# 1970 - 1973 Corvette: Service Bulletin: Engine Overheat

**Model and Year:** 1970 - 1973 Corvettes with 454 Cu. In. Engines and Air Conditioning

**Bulletin Number:** 73-T-28, Section VI

**Date:** May 14, 1973

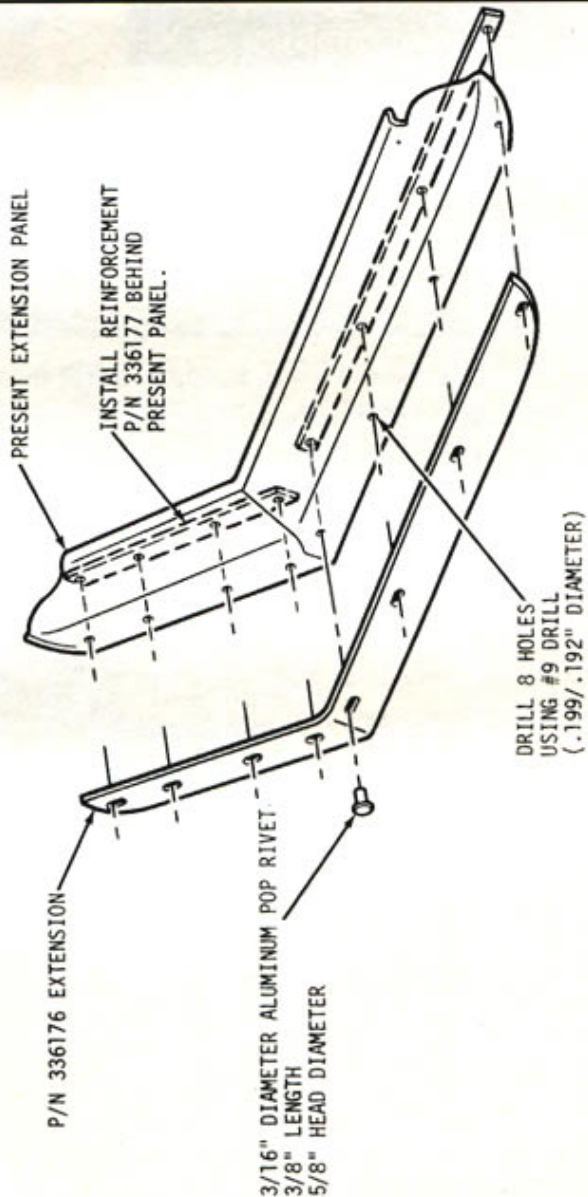
To improve low speed cooling, an additional grille panel lower extension was installed in 1973 Corvettes produced after Vehicle Identification Number 1Z37Z3S410722. This extension, Part Number 336176, may be installed as illustrated on page 2 of this bulletin on early 1973 Corvettes only .
